Tsi107™ Revision 1.3/1.4 Device Differences

80C2000_AN002_02

This document describes electrical and functional differences between Revision 1.3 and Revision 1.4 of the Tsi107 PowerPC Host Bridge, which provides system interconnect between PowerPC processors, PCI peripherals and local memory.

Figure 1. Rev 1.3 and Rev 1.4 \overline{DBGn} Signal Timing

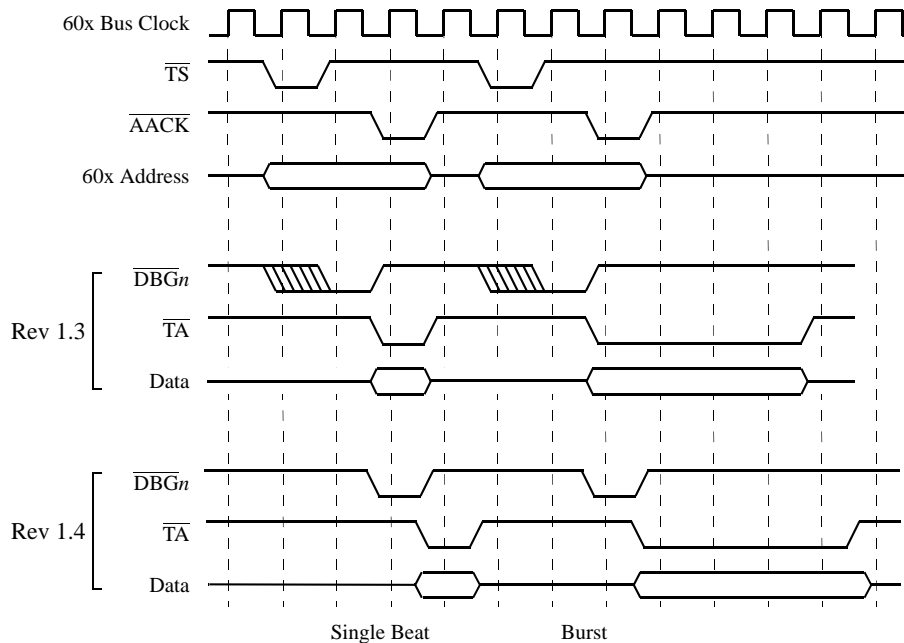
As described in Section 3.2, “MPC7450 Compatibility,” to guarantee that \overline{TA} is not asserted on or before \overline{AACK} , the timings for \overline{DBGn} and \overline{DBGLB} were changed in Rev 1.4 to fix the MPC7450-compatibility problem. Before Rev 1.4, the Tsi107 may drive \overline{DBGn} (and \overline{DBGLB}) as early as the cycle in which \overline{TS} is asserted. Figure 1 shows the signal timing for \overline{DBGn} and \overline{DBGLB} on Rev 1.3 and Rev 1.4 devices.

For Rev 1.4 of the Tsi107, \overline{DBGn} is asserted coincident with \overline{AACK} . If a Rev 1.3 system design incorporates external logic that depends on the timing of \overline{DBGn} or \overline{DBGLB} , the external logic must be modified to accommodate the altered timing of Rev 1.4.
